**MEETING NOTICE AND AGENDA
BELOIT LANDMARKS COMMISSION
Tuesday, September 20, 2016, 7:00 PM
The Forum, 100 State Street**

REPORT TO THE BELOIT LANDMARKS COMMISSION

Location: 700 College Street (Campbell Hall)

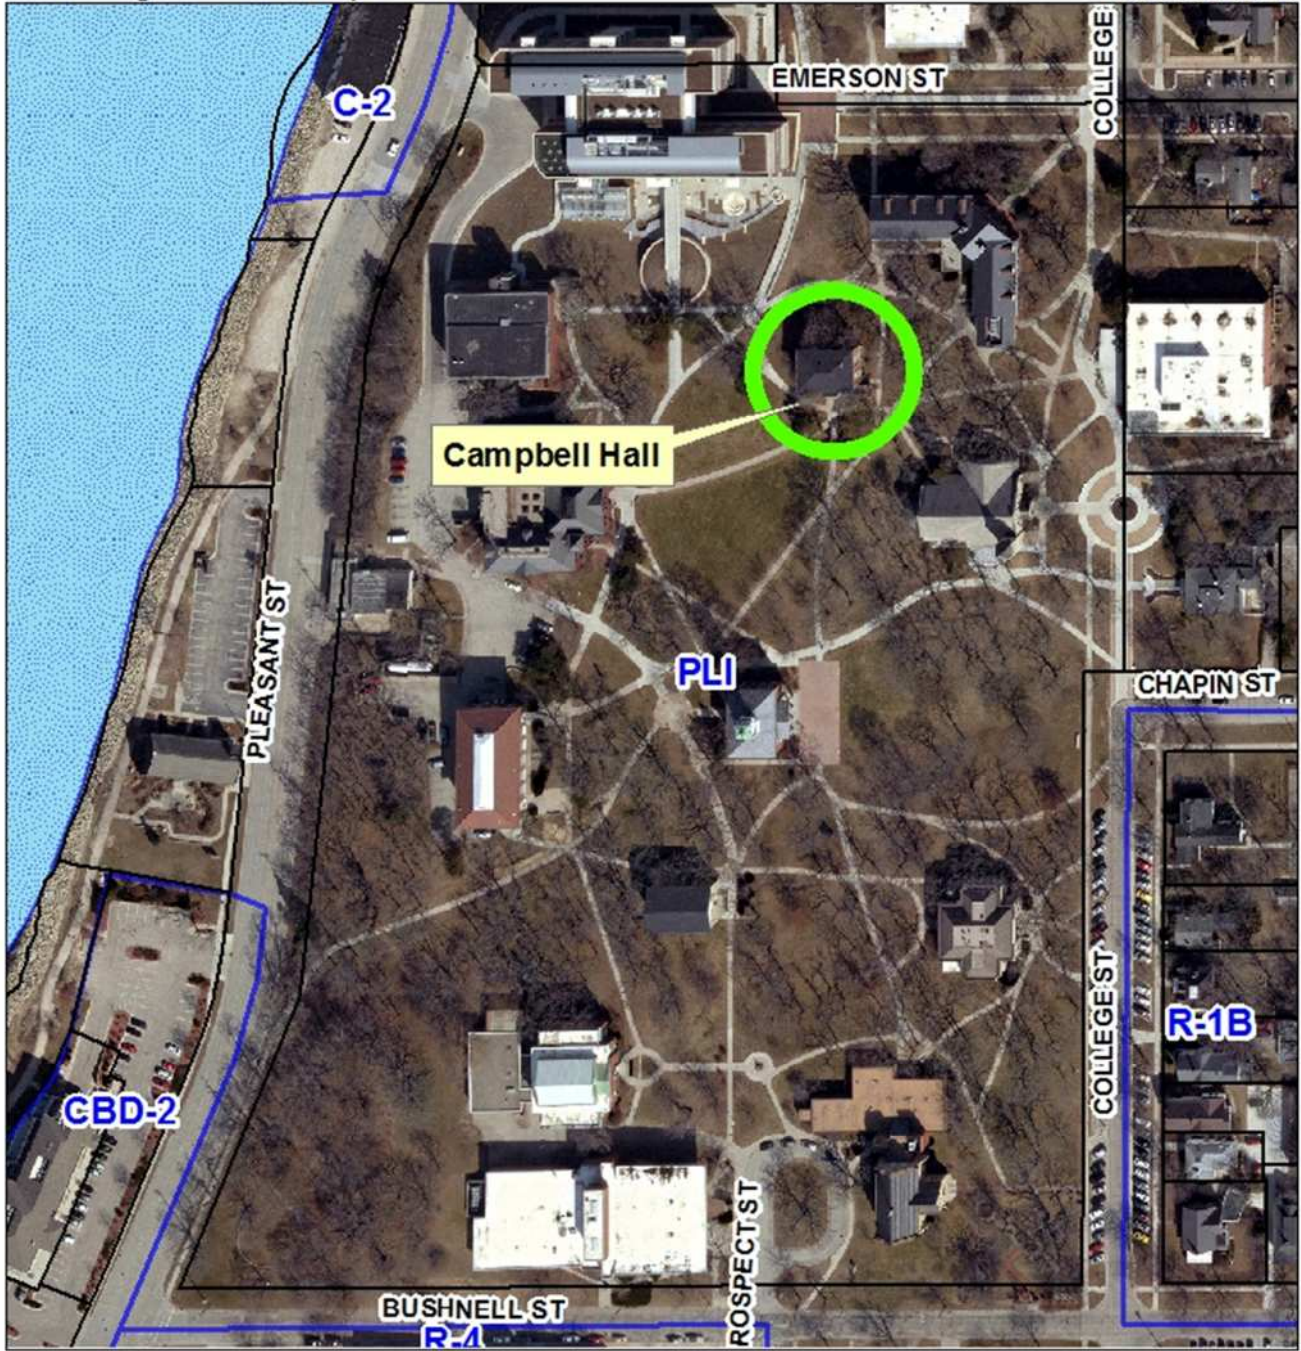
The original plan for the portico was to replace the deteriorating bases on each of the eight columns with polyurethane bases and reinstall all eight columns. However, after installing the ramp up to the entranceway, the applicant and Beloit College discovered that leaving off two of the rear columns would provide more space to those using the ramp in order to access the building. The applicant is requesting the Landmarks Commission amend the COA approved on May 17, 2016 to allow for the installation of only six of the eight original columns.

The project is complete (see photo below), but the columns can be installed if the Commission denies the COA amendment request.

The Planning & Building Services Division recommends **approval** of a Certificate of Appropriateness to rebuild part of the front portico, remove the existing ramp and install a new ramp, and install hardscape elements at the Campbell Hall institutional structure located at 700 College Street on the Beloit College Campus, based on the standards and criteria contained in the Historic Preservation Ordinance and subject to the following conditions:
